ROAD SAFETY AUDIT

11893- Kingston Stables Ltd.

Residential Development at Kingston, Knocknacarra, Galway.

Stage 1/2 RSA

Figure 2-1: Tie into Existing Network

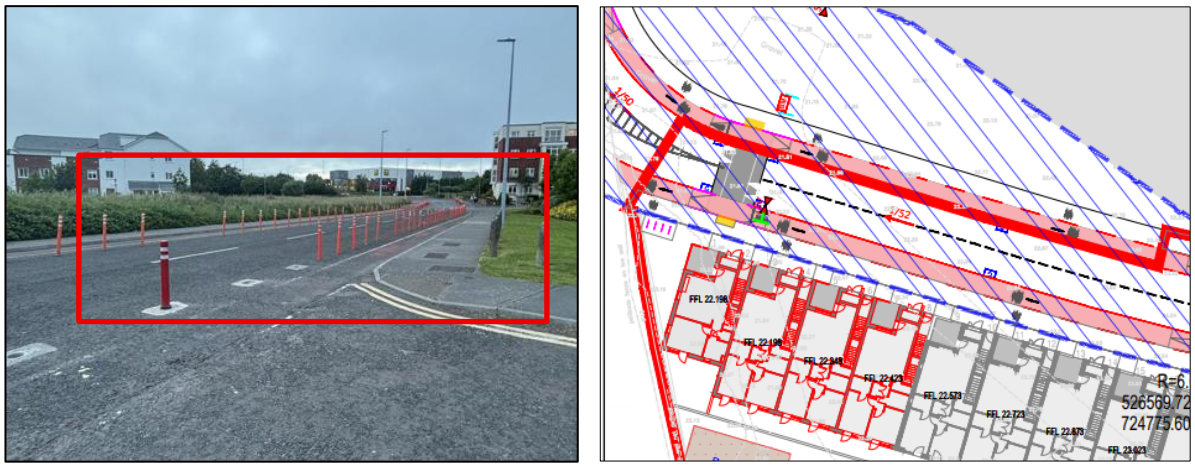
Existing Road Network

The Audit Team observed that the existing road network consists of a rapid build cycle lane on Altan Road. The Audit Team is concerned that this temporary traffic management measure may create uncertainty for cyclists crossing Altan Road to gain access to northbound lane. This may result in sudden manoeuvres by cyclists who may remain on the carriageway. This could lead to a collision between a cyclist and a vehicle.

The Design Team should provide a permanent cycle lane in accordance with the relevant design standards, ensuring a suitable transition between the existing and proposed cycle facilities.

Figure 2-2: Example of missing road marking

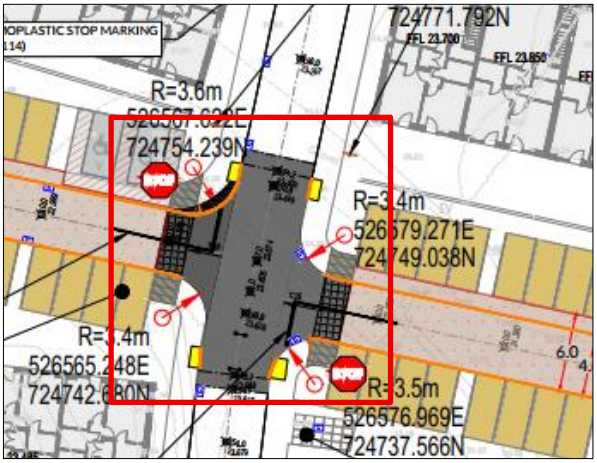
STOP Road Marking

The Audit Team observed that no STOP road markings have been provided at key junctions within the proposed development. This omission raises safety concerns, as the absence of clear priority control may lead to driver confusion and increase the risk of side on collisions.

The Design Team should incorporate appropriate STOP road markings in accordance the Traffic Signs Manual.

Figure 2-3: Proposed Raised Junction

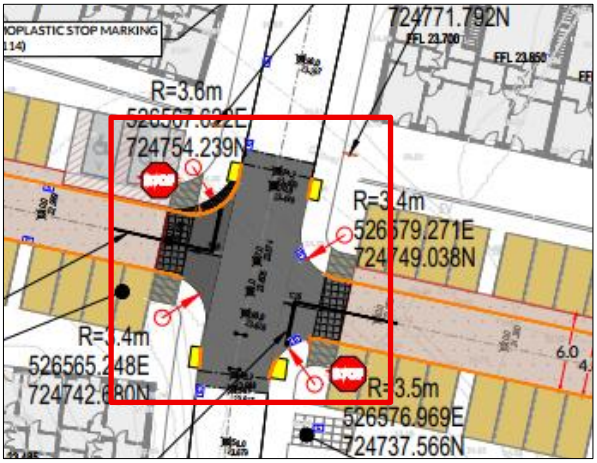
Missing Road Marking

The Audit Team notes that no road markings have been provided on the raised junction. The Audit Team is concerned that approaching drivers may not be adequately warned of the upcoming traffic calming feature. This could result in vehicles failing to reduce speed, striking the ramp, and making a sudden manoeuvre onto the footpath, resulting in a collision with a vulnerable road user (VRU).

The Design Team should ensure road markings are provided at the raised junction and that they comply with the requirements of the Traffic Signs Manual (TSM).

Figure 2-4: Proposed footpath

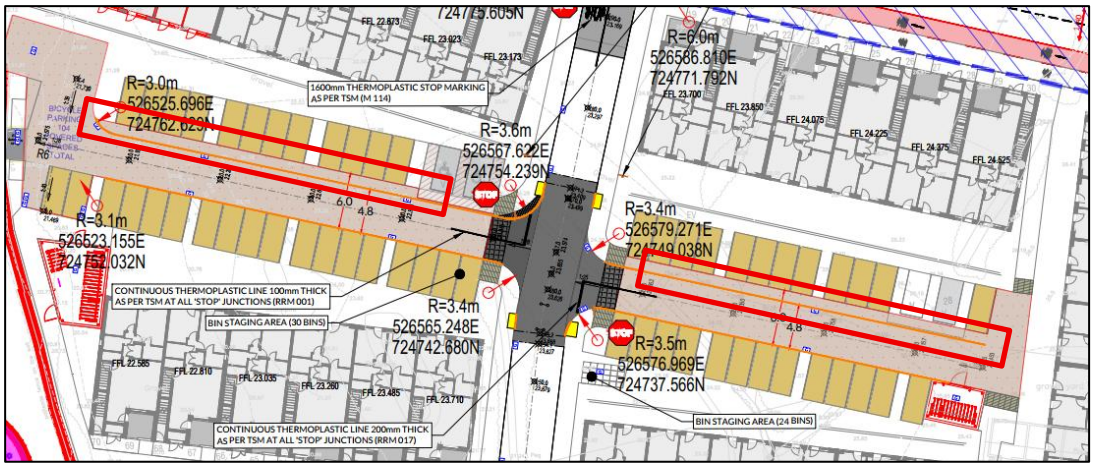
Footpath Location

The Audit Team observed that the proposed footpath is located to the rear of the parking spaces. The Audit Team is concerned that vulnerable road users, particularly children, may be obscured by parked vehicles while vehicles are manoeuvring into or reversing out of parking spaces. This may result in collisions between vehicles and vulnerable road users

The Design Team should relocate the footpath to the front of the parking spaces to minimise conflicts between pedestrians and reversing vehicles.

Appendix A-II PROBLEM MAP

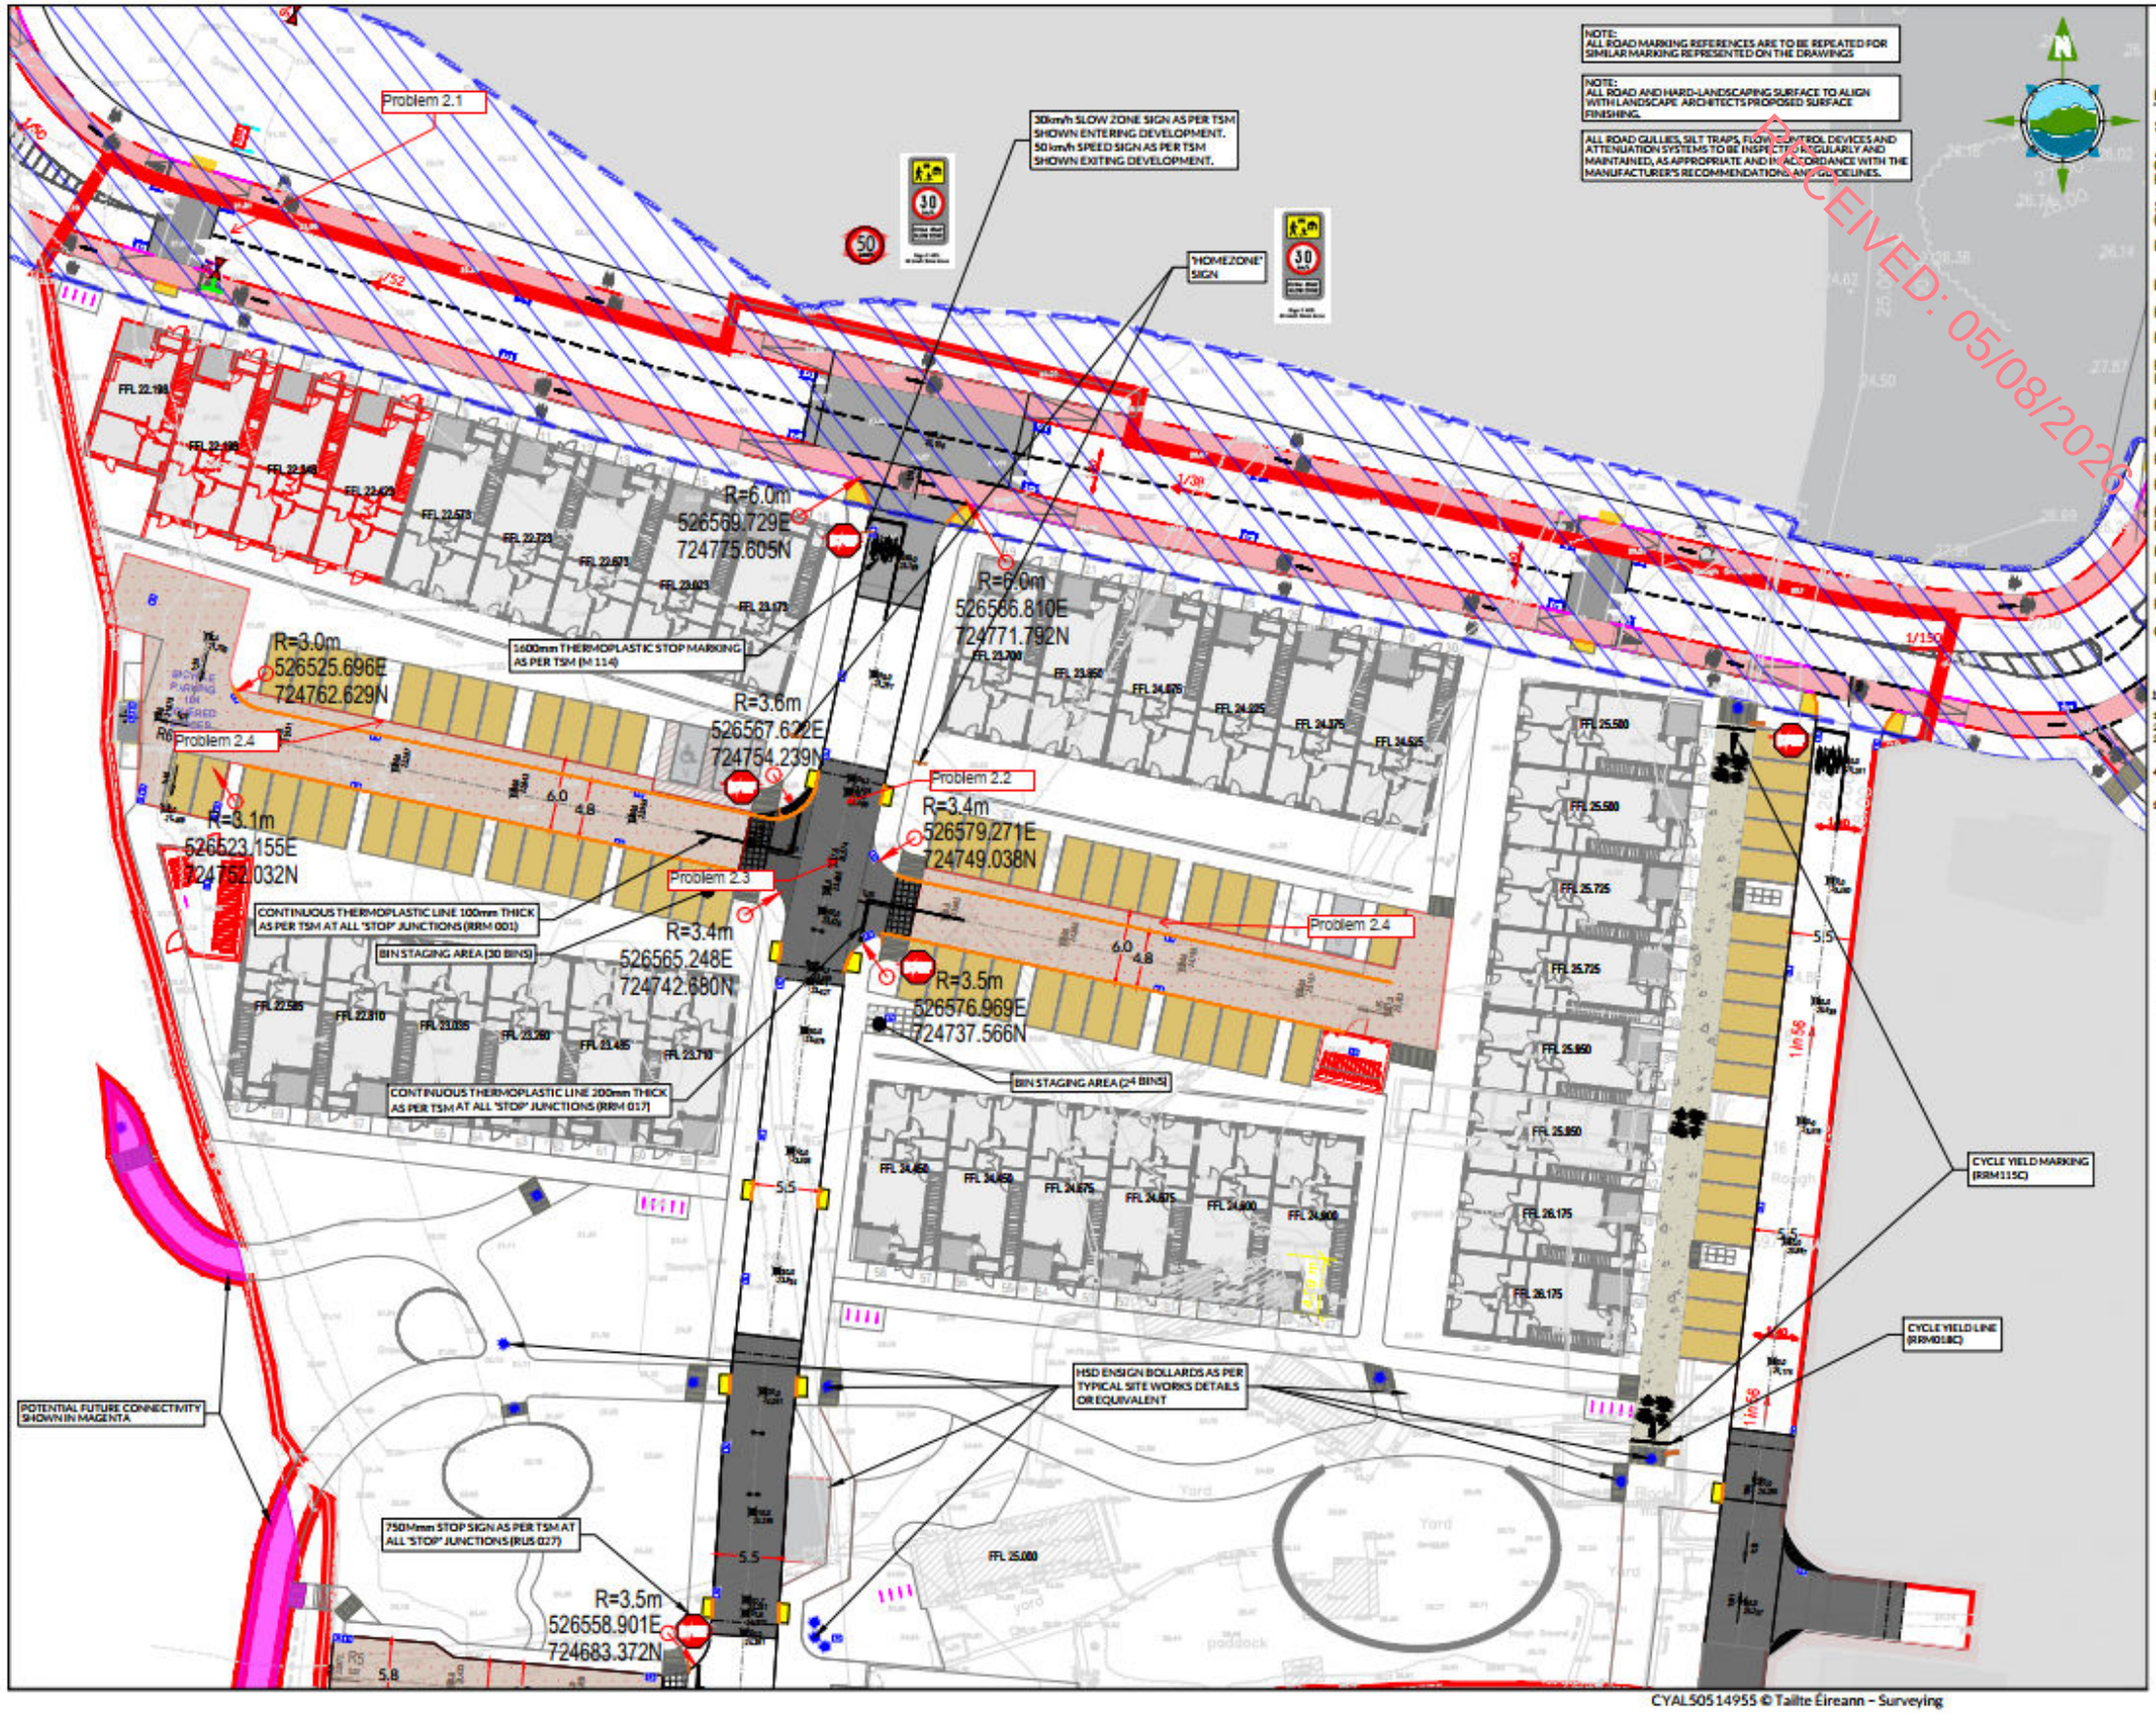
Problem 2.1
30km/h SLOW ZONE SIGN AS PER TSM SHOWN ENTERING DEVELOPMENT. 50 km/h SPEED SIGN AS PER TSM SHOWN EXITING DEVELOPMENT.
"HOMEZONE" SIGN
R=6.0m
526569.729E
724775.605N
R=6.0m
526566.810E
724771.792N
1600mm THERMOPLASTIC STOP MARKING AS PER TSM (M 114)
R=3.0m
526525.696E
724762.629N
Problem 2.4
R=3.6m
526567.622E
724754.239N
Problem 2.2
R=3.4m
526579.271E
724749.038N
R=3.1m
526523.155E
724752.032N
Problem 2.3
CONTINUOUS THERMOPLASTIC LINE 100mm THICK AS PER TSM AT ALL 'STOP' JUNCTIONS (RRM 001)
BIN STAGING AREA (30 BINS)
R=3.4m
526565.248E
724742.680N
R=3.5m
526576.969E
724737.566N
CONTINUOUS THERMOPLASTIC LINE 200mm THICK AS PER TSM AT ALL 'STOP' JUNCTIONS (RRM 017)
BIN STAGING AREA (24 BINS)
CYCLE YIELD MARKING (RRM115C)
CYCLE YIELD LINE (RRM018C)
HSD ENSIGN BOLLARDS AS PER TYPICAL SITE WORKS DETAILS OR EQUIVALENT
POTENTIAL FUTURE CONNECTIVITY SHOWN IN MAGENTA
750Mmm STOP SIGN AS PER TSM AT ALL 'STOP' JUNCTIONS (RUS 027)

To be Completed by Designer				To Be Completed by Audit Team Leader
Paragraph No. in Safety Audit Report	Problem accepted (yes/no)	Recommended Measures Accepted (yes /no)	Alternative Measures (describe). Give reason for not accepting recommended measure	Alternative Measures or reasons accepted by auditors (yes /no)
2.1	YES	YES		
2.2	YES	YES		
2.3	YES	YES		
2.4	YES	NO	The area in question is a shared surface/Homezone area and has been designed to promote low vehicle speeds and a pedestrian-priority environment. Soft landscaping is proposed behind the carparking spaces. The previously proposed dropped kerb delineation in front of the parking has been omitted and the surface finish is now continuous across the full width of the space.	Yes
